## Introduction

Thank you for your interest in the Xilinx XC3S700A FPGA device engineering samples. Although Xilinx has made every effort to ensure the highest possible quality, these devices are subject to the limitations described in this errata notification.

Table 1: XC3S700A Devices Affected by These Errata

Figure 2: DCM DFS Lock Failure Workaround

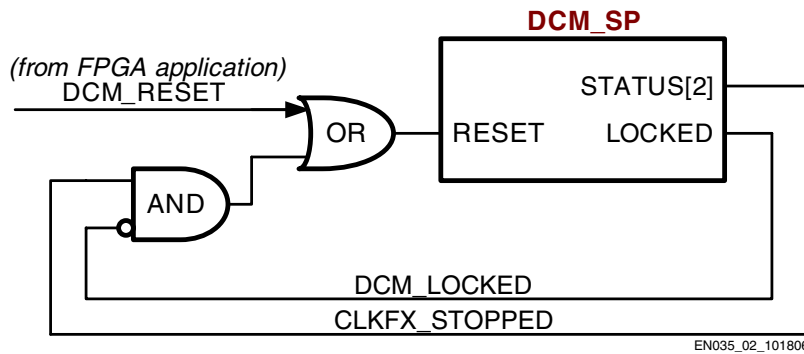
A small number of DCM DFS locking failures have been observed during characterization.

A software workaround exists, as shown in [Figure 2](#). This circuit is automatically inserted by the ISE development software starting with version 9.1i. Using FPGA logic, the circuit monitors both the LOCKED output from the DCM\_SP function and the STATUS[2] bit, which indicates that the DFS output CLKFX has stopped. If LOCKED = 0 and STATUS[2] = 1, then the circuit asserts the DCM RESET input. If the FPGA application also resets the DCM, then OR the reset signal from the FPGA application with the monitored output signals.
